BID ADDENDUM

State Project No: H27-6094	PROJECT NAME: Williams Brice Nursing Building and Auditorium Roof Replacement	ADDENDUM NO.: Two ADDENDUM ISSUE DATE: June 4, 2015
--------------------------------------	---	---

2 ROOF EDGE
SCALE: 2"=1'-0"

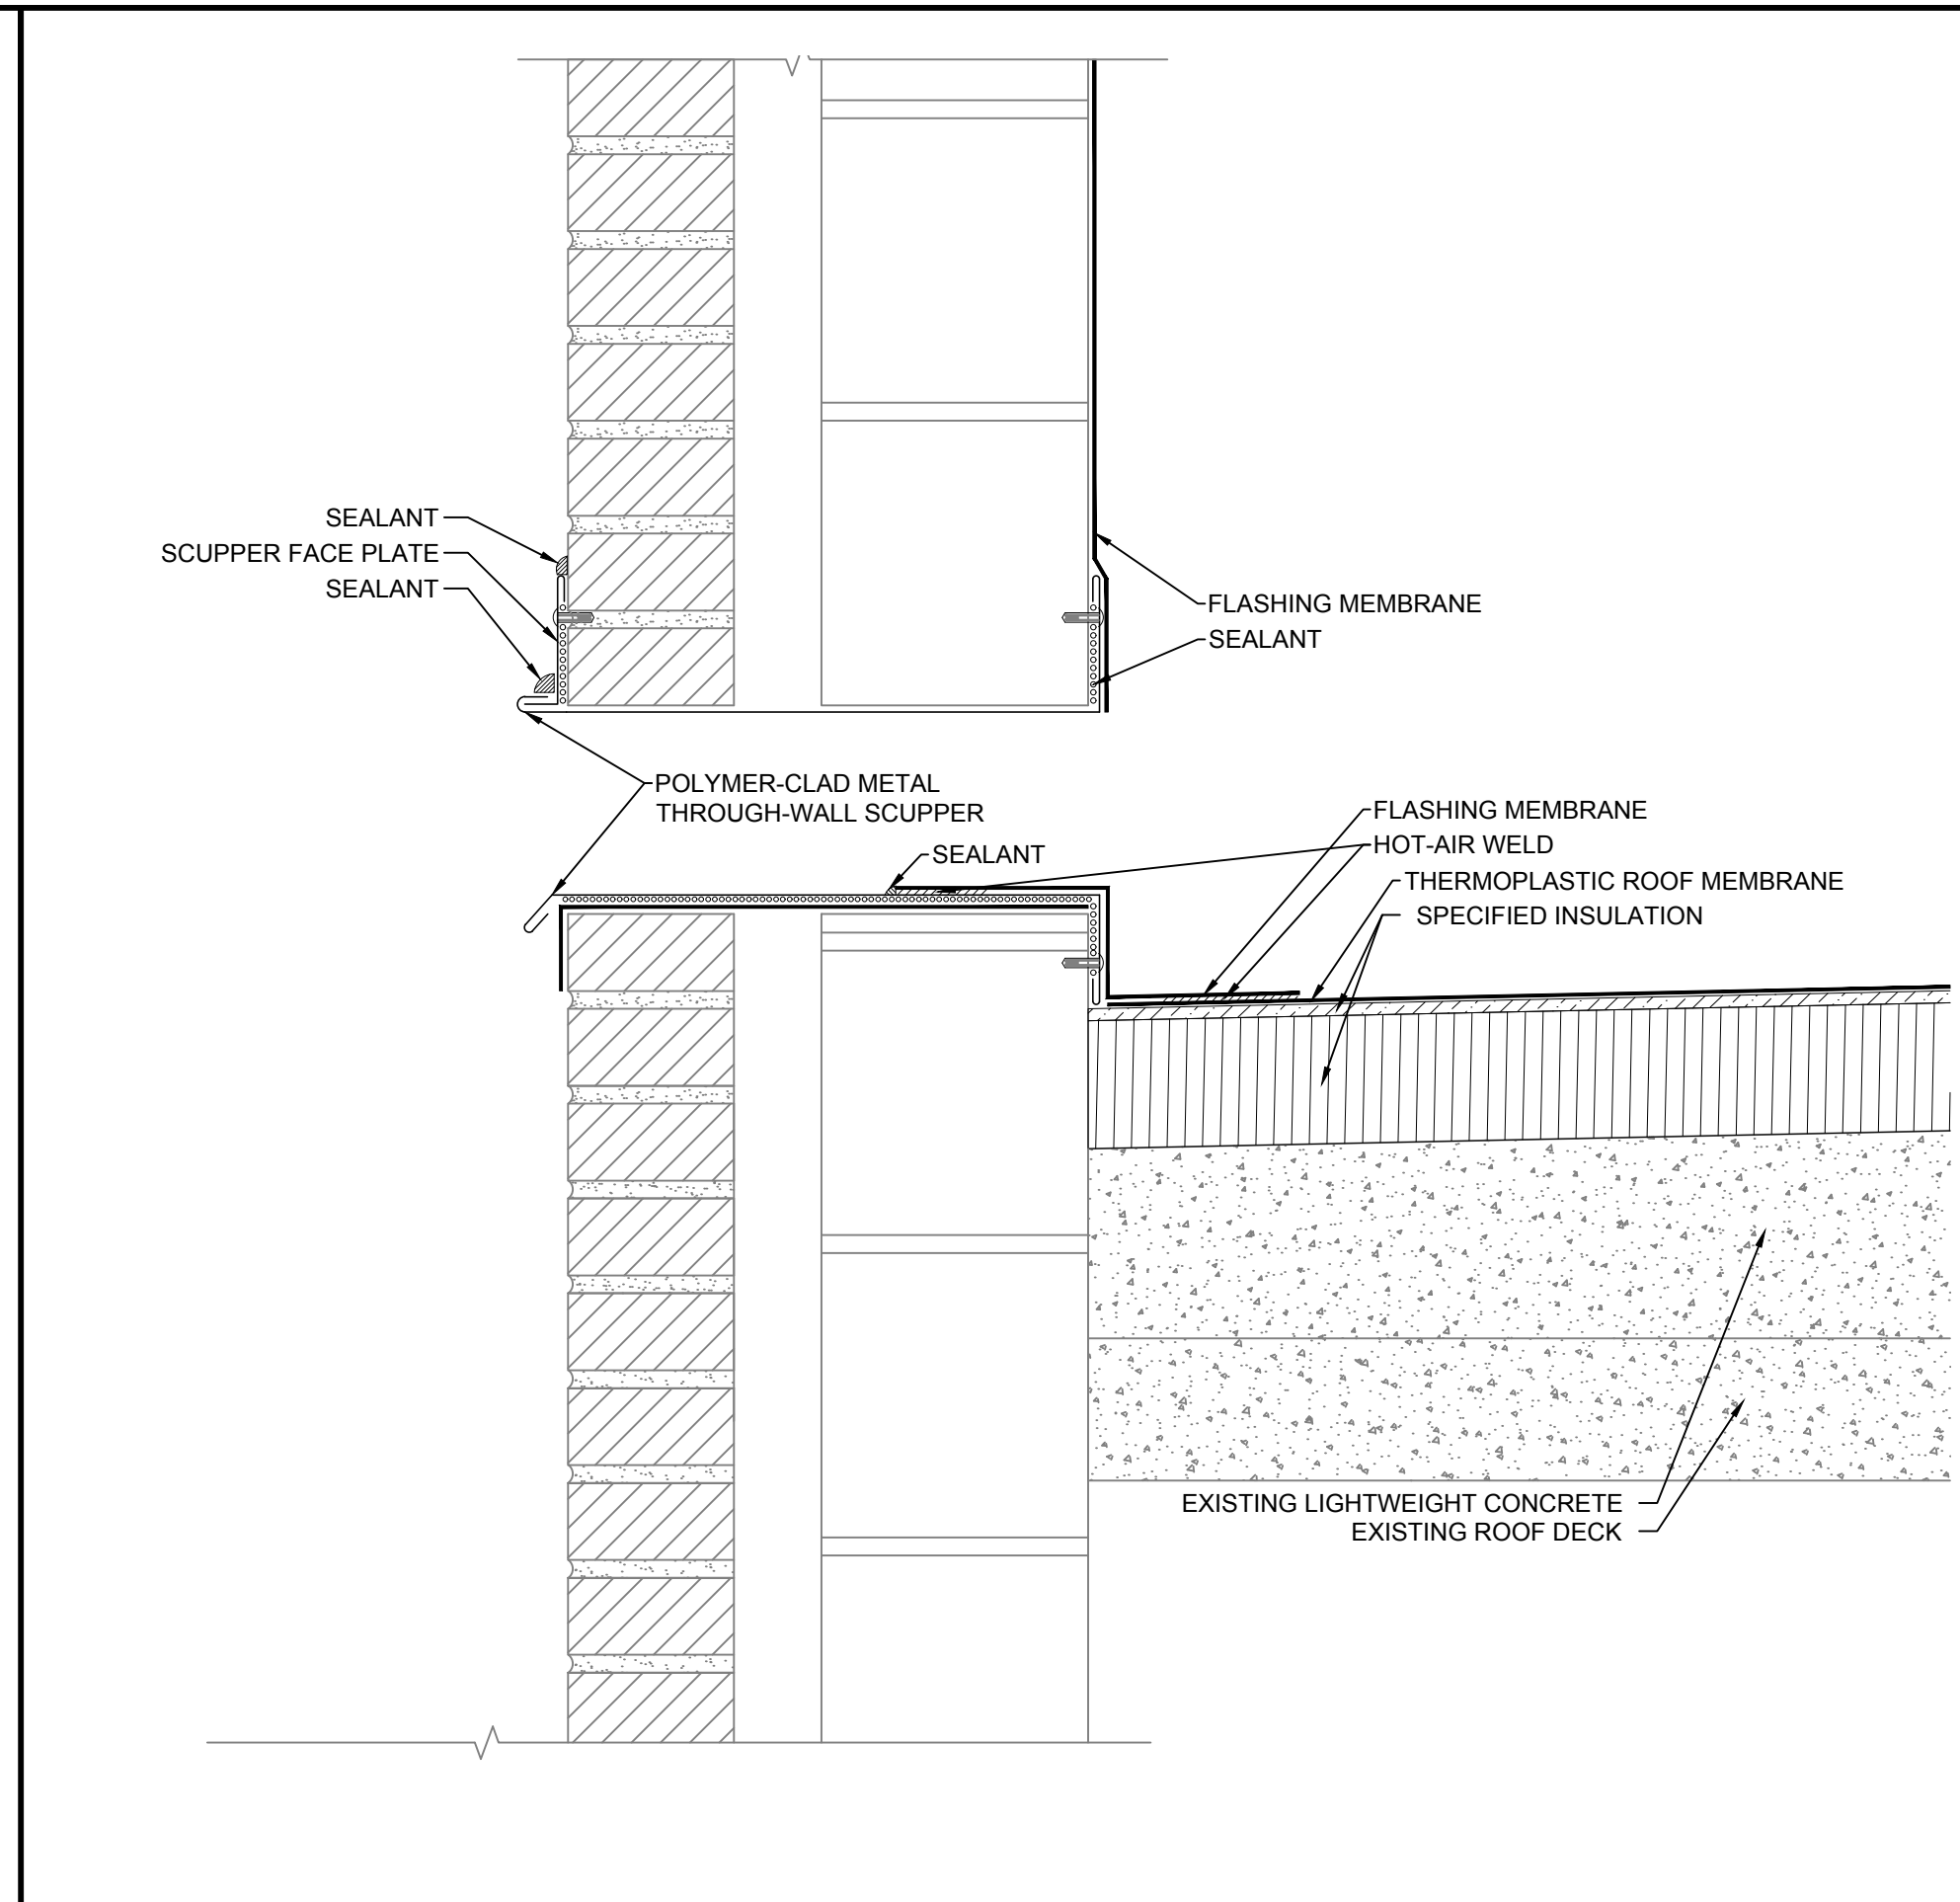
- Q1:** The plan view of roof areas B & D indicate gutters and down spouts at the low edge of the roof. Sections 2 & 6/R201 do not show this gutter. On roof area D there is an existing gutter. Do we provide gutter and down spout at these locations?

- A1:** Yes, refer to Drawing R-201 revised 06/04/2015.
- Q2:** Sections 2 & 6/R201 indicate a water stop built into the PVC clad metal with a prefinished cladding. Shouldn't this be a drip without a water stop? And, is the cladding necessary?

- A2:** Provide gravel stop as shown on Drawing R-201 revised 06/04/2015 to allow securement of edge metal cover plate.
- Q3:** On Section 16/R203 for roof area D the detail is to go over the existing sheet metal wall panel with a PVC clad piece of drip edge without a water stop or color cladding? Should this have a water stop and cladding, with the cladding to match the metal wall panel?
